London Road, Rayleigh Essex Flood Risk Assessment Addendum

May 2015

Figure 1: Location of Church Road in relation to the Proposed Development

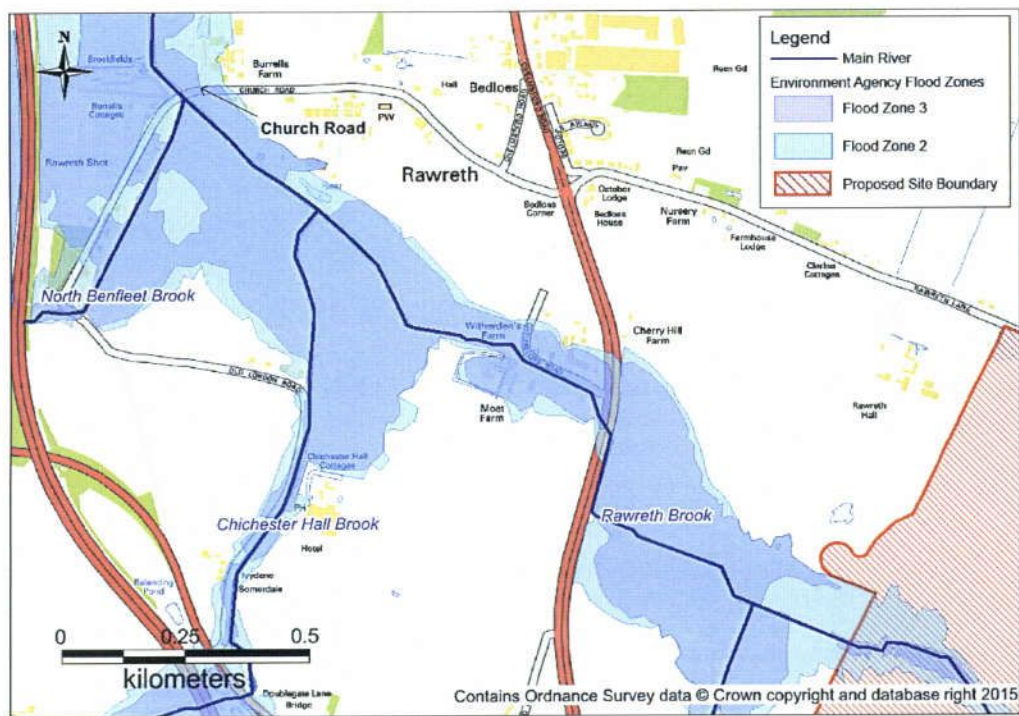
The Council's reason for refusal states that the FRA did not take account of flooding events at Church Road, Rawreth. Church Road is located approximately 2km downstream of the Application Site. The location of Church Road in relation to the Application Site is shown in Figure 1 below. The Chichester Hall Brook joins the Rawreth Brook 0.7km upstream of Church Road. The North Benfleet Brook joins the Rawreth Brook at the inflow of the culvert beneath Church Road. The Environment Agency Flood Maps indicate Church Road and the surrounding area to largely be within Flood Zone 3 (land assessed as having a 1 in 100 or greater annual probability of river flooding (>1%), or a 1 in 200 or greater annual probability of flooding from the sea (>0.5%) in any year).

Church Road is at an elevation of 5m AOD, approximately 5m lower than the Application Site (at 10m AOD). Although a significant distance downstream of the proposed development, there is potential for surface water runoff to be routed towards Church Road, via the Rawreth Brook. If left unmitigated, there is the potential that the flood risk at Church Road would be increased.

The FRA however outlined that the surface water runoff from the proposed development would be mitigated. This will be achieved through the development of a surface water drainage network, utilising Sustainable Drainage Systems (SuDS). The network would manage surface water runoff up to and including the 1% Annual Exceedance Probability (AEP) (1 in 100 year) plus 30% Climate Change event.

Figure 2: Draft AECOM model results against existing Environment Agency Flood Zones

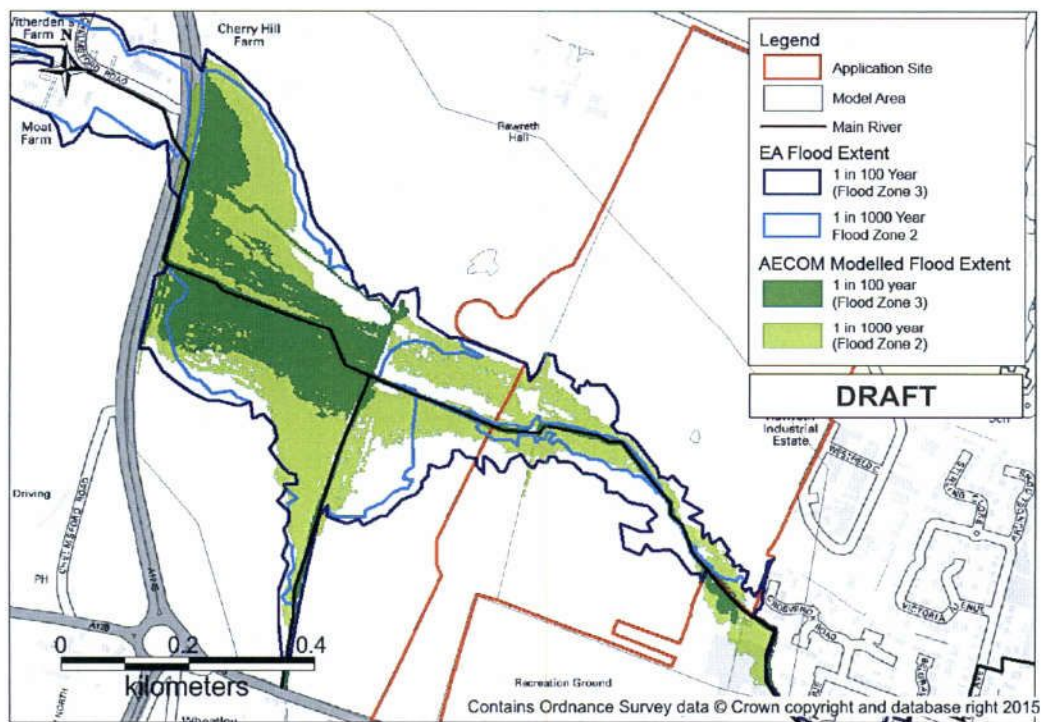
The draft results of the updated modelling show the flood extent across the Application Site has been reduced. This demonstrates that the original 1D model overestimated flooding across the Application Site. Figure 2 outlines the draft model results for the 1% AEP (1 in 100 year) and 0.1% AEP (1 in 1000 year) flood extents against the Environment Agency Flood Zone extents. The flood extents of the revised modeling are mapped only within the 2D model domain area.

At the Application Site, the draft results of the updated modelling demonstrate that the Rawreth Brook remains in bank for the lower return period flood events (10% AEP (1 in 10 year) and 5% AEP (1 in 20 year)). Flooding occurred during the 10% AEP (1 in 10 year) event downstream of the Application Site at the confluence of the Rawreth Brook main river tributary. This results in flooding of the land to the west of the field crossing, downstream of the Application Site.
